Access Compliance Report

Public Rights-of-Way

(Curb Ramps)

Intersection ID: 3215	Main Street: BELLMORE_CT	Cross Street: OLD_BRIDGE_LN	Location: S
ADA ID: 14092D28A1BA	Ramp Type: Perp	Initial Pass/Fail: Pass	Overall Compliance: No
Severity Score: 0			
Codes/Mitigation Info/Possible Solution		Field Measurements/Component Compliance

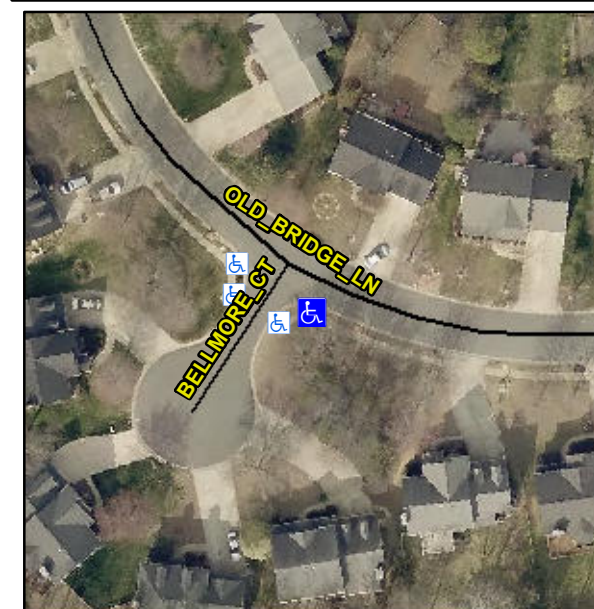
Not Found, R304.2.1, R304.5.3, R305.2

Compliance	Description	Data	Compliance	Description	Data
N/A	Ramp Length (in)	48.0	Yes	Ramp Slope (%)	5.4
Yes	Ramp Width (in)	48.0	Yes	Ramp XSlope (%)	1.6
N/A	Flare Type LT	Sloped	N/A	Flare Type RT	N/A
N/A	Flare Slope LT (%)	2.2	N/A	Flare Slope RT (%)	1.8
N/A	Flare Traversable LT?	No	N/A	Flare Traversable RT?	No
No	Landing Length (in)	47.0	Yes	DWS Provided?	Yes
Yes	Landing Width (in)	48.0	Yes	DWS Contrast?	Yes
Yes	Landing Slope (%)	1.6	Yes	DWS Length (in)	25.5
No	Landing X Slope (%)	2.4	Yes	DWS Full Width?	Yes
N/A	Landing Curb? (Y/N)	No	No	DWS Offset (in)	3.0
N/A	Shared Landing?	No			
Yes	Gutter Ponding?	No	Yes	Gutter Slope (%)	0.9
Yes	Gutter Lip Ht (in)	0.0	Yes	Gutter X Slope (%)	1.2
N/A	Painted X Walk1?	No	N/A	Painted X Walk2?	N/A
	X Walk 1 Direction	To NE		X Walk 2 Direction	N/A
N/A	X Walk 1 Width (in)	N/A	N/A	X Walk 2 Width (in)	N/A
	X Walk 1 Slope (%)	9.9		X Walk 2 Slope (%)	N/A
	X Walk 1 X Slope (%)	1.7		X Walk 2 X Slope (%)	N/A

N/A	Ramp inside XWalk1?	N/A	N/A	Ramp inside XWalk2?	N/A
	Road Slope (%)	N/A	N/A	Clear Space?	Yes
	Road X Slope (%)	N/A	N/A	Clear Space to XWalk (in)	N/A
Yes	Any Obstructions?	No	Yes	Storm Grate/Utility Hazard?	No
	Obstruction Type			Storm Grate/Utility Type	
		N/A			N/A
			Yes	Surface Condition? (G/P)	Good

Remove & Replace Entire Ramp.
